UNITED STATES PATENT AND TRADEMARK OFFICE

APPLICATION NO.	FILING DATE	FIRST NAMED INVENTOR	ATTORNEY DOCKET NO.	CONFIRMATION NO.
09/913,635	12/11/2001	Helmut Ruckert	AP9673	3938
10291	7590	04/08/2005	EXAMINER	
RADER, FISHMAN & GRAUER PLLC 39533 WOODWARD AVENUE SUITE 140 BLOOMFIELD HILLS, MI 48304-0610			BURCH, MELODY M	
			ART UNIT	PAPER NUMBER
			3683

Office Action Summary

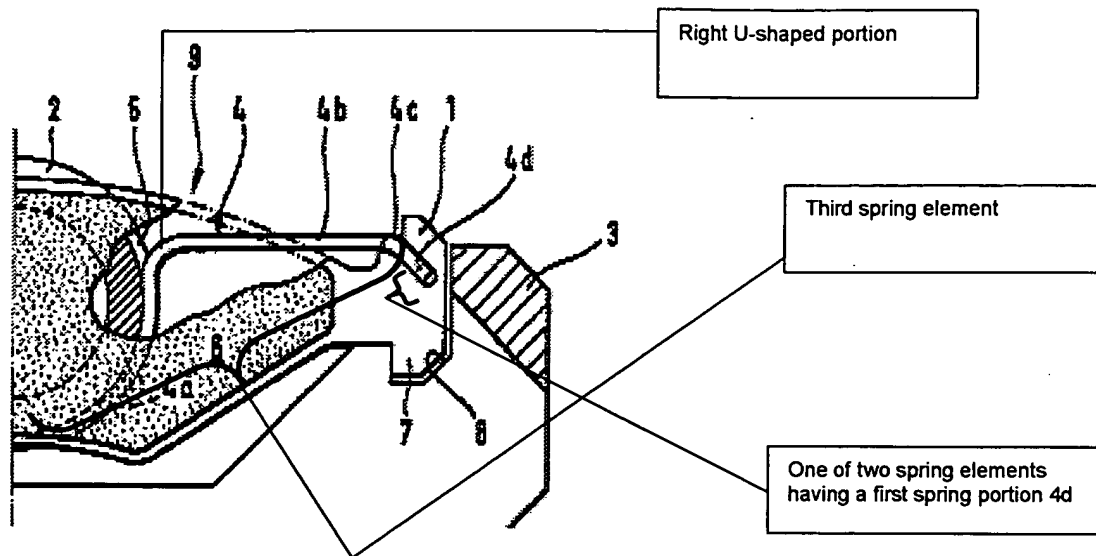
Re: claims 28, 31, 32 and 34. Winter shows in figure 1 a brake pad 9 and brake piston assembly, comprising: a brake piston 2 having an axis and an outer surface encircled by a circumferential groove 5, a retaining spring 4 coupled to a brake pad 1,6, wherein the retaining spring engages the circumferential piston groove as shown in figure 2, thereby detachably coupling the brake pad to the piston, wherein the retaining spring includes two spring elements as labeled in the modified version of figure 1 on pg. 4 of the Office Action arranged opposite each other with respect to the piston axis, each spring element having a first spring portion left and right side elements 4d which applies an axial spring force as discussed in the second paragraph on pg. 4 of the translation of Winter at a contact point location on opposite sides of the piston to urge the brake pad against the piston, and a third spring element as labeled on pg. 4 arranged between the two spring elements (left and right spring elements) having a second spring portion 4c which applies a radial spring force as discussed in the second paragraph on pg. 4 of the translation of Winter to the brake pad at one contact point location in a vertical direction which is generally perpendicular to the piston axis.

8. Applicant's arguments with respect to claims have been considered but are moot in view of the new ground(s) of rejection. Examiner has considered an alternate perspective of Winter. With regards to claim 31, it is noted that the claim language does not preclude the use of spring sections as spring elements. Examiner notes that the first definition in section 2 of the definition of the word "element" provided by Applicant is "a constituent part". Examiner notes that the spring elements shown in the modified version of figure 1 on pg. 4 of the Office Action are constituent parts.
